UN#10-129

Subject: UniStar Nuclear Energy, NRC Docket No. 52-016  
Response to Request for Additional Information for the  
Calvert Cliffs Nuclear Power Plant, Unit 3,  
RAI 219, Response to Questions 02.05.01-66 through 69,  
Basic Geologic and Seismic Information

**Response to NRC RAI 219, Questions 02.05.01-66, 67, 68 and 69,**

Figure 5 LiDAR Elevation Showing Trace of Pazzaglia's Fault

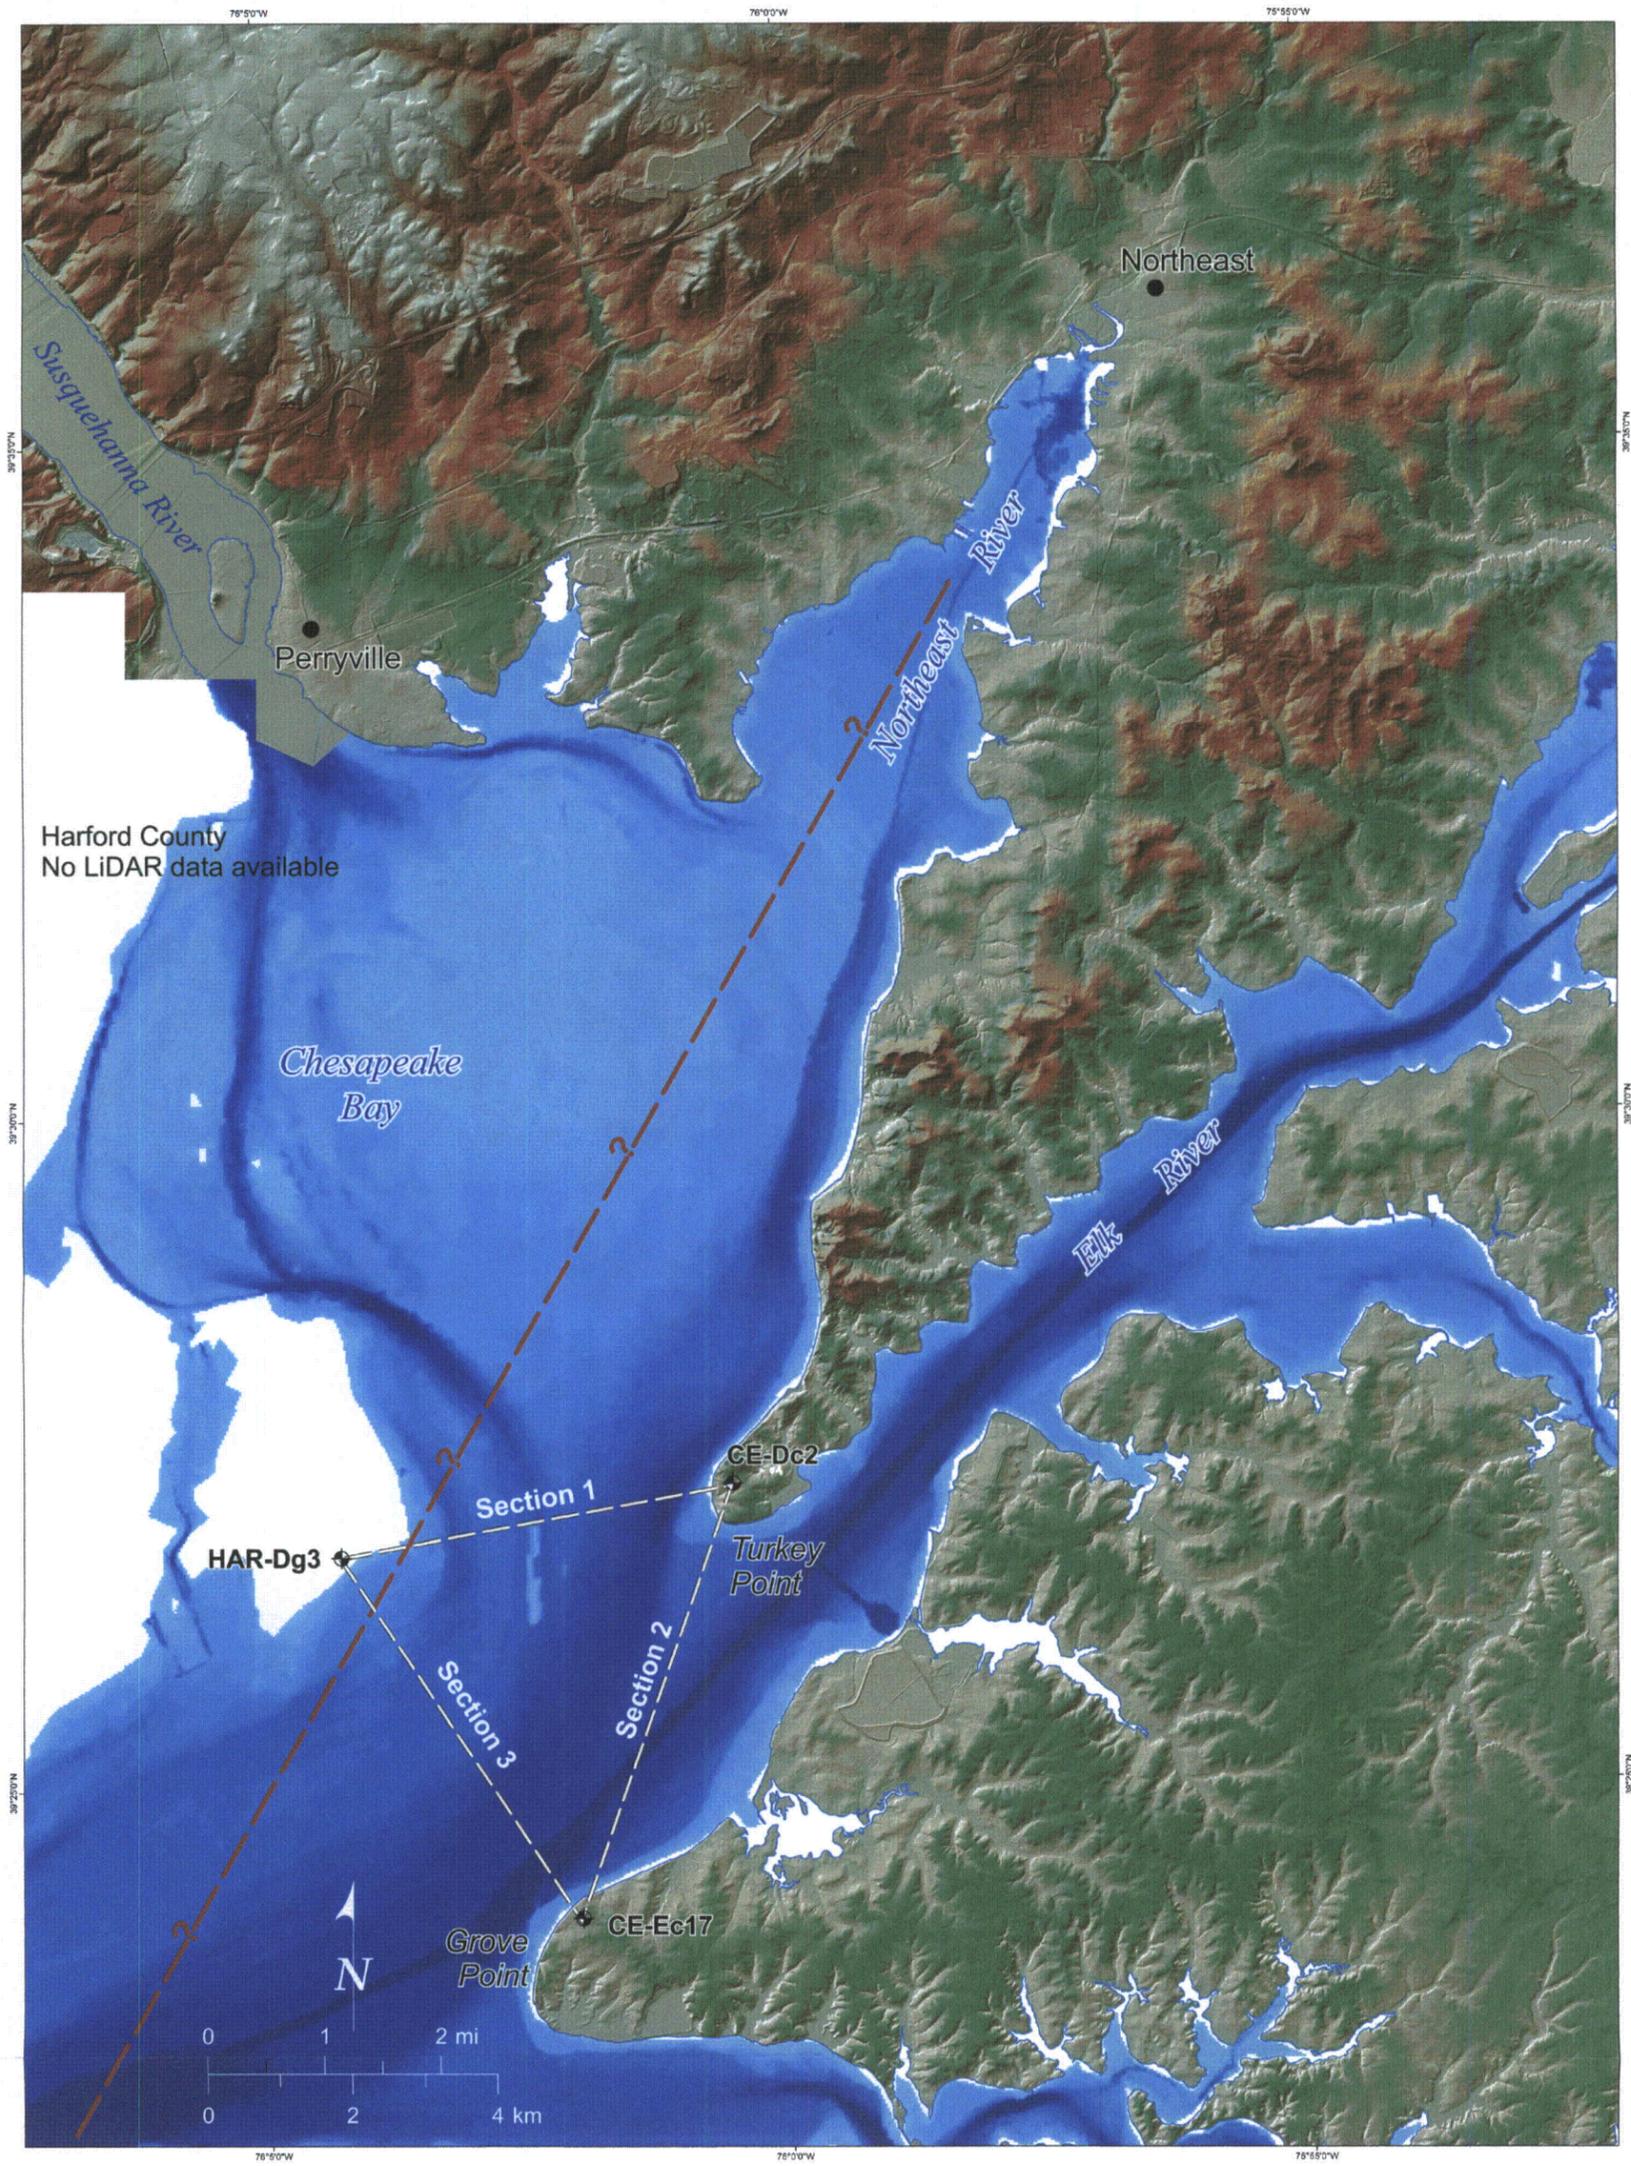
- **The LiDAR surface map provided in your response is inconclusive because an 8 m elevation difference across the fault would not show in Figure 6 at the scale presented. Furthermore, locating a fault that is "coming ashore" would require examination all along the coast line at a large scale resolution (close in detail). Pazzaglia's dotted line is an approximation of the location of his interpreted fault. This also applies to examination of the bay bathymetry.**

- (5) There is no obvious fault scarp-morphology along the northeast projection of the hypothetical fault as determined through aerial reconnaissance and review of 'bare earth' topographic data (LiDAR data) (Figure 5).

The LiDAR surface map provided as Figure 6 from RAI 130 Question 02.05.01-48<sup>2</sup> was evaluated at a large scale in an effort to identify possible fault related features along the coast line of the Northeast River. This figure is reproduced in this response as Figure 5 and is included electronically as a large high resolution version in Enclosure 2. In addition, this figure will be included in the COLA as FSAR Figure 2.5-304.

Figure 2.5-306 (Geologic Map of the Ramapo Fault and Vicinity with Seismicity)

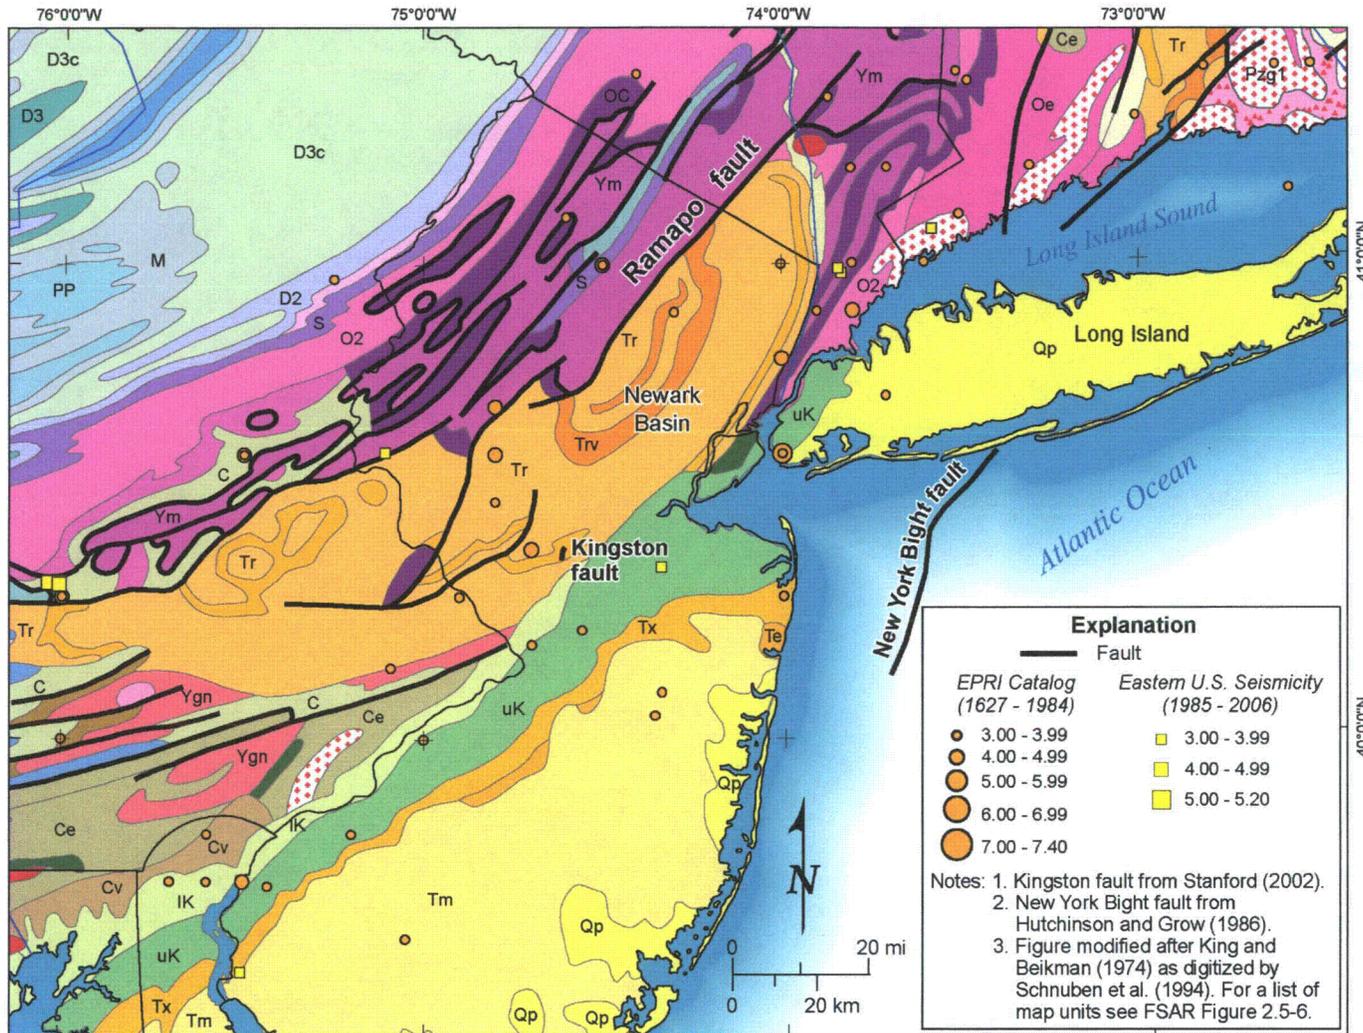
NRC staff note that the discussions in the original FSAR about these faults cannot be understood without additional illustrations/maps beyond Figure 2.5-31. The map and cross section of the Kingston fault is needed to understand the uncertainty of the interpretation of a fault in the first place. It is difficult to understand the general geologic setting and relative position of these faults to each other as well. Please explain why you do not plan to include a more illustrative map/figure to support the text.

Several of the figures generated previously in response to RAI 70 Question 02.05.01-24<sup>1</sup> will be added to the FSAR as new figures (Figures 2.5-306, 2.5-307 and 2.5-308). These figures illustrate the geologic setting of the Ramapo, Kingston, and New York Bight faults. These new FSAR figures provide additional fault location information by which one can better understand the general geologic setting, as well as the regional location of the faults with respect to one another. It may be noted that the FSAR Figure 2.5-307 is a reproduction of the geologic map by Stanford (2002) for the Kingston fault and is shown at a larger scale than the original mapping of 1:24,000.
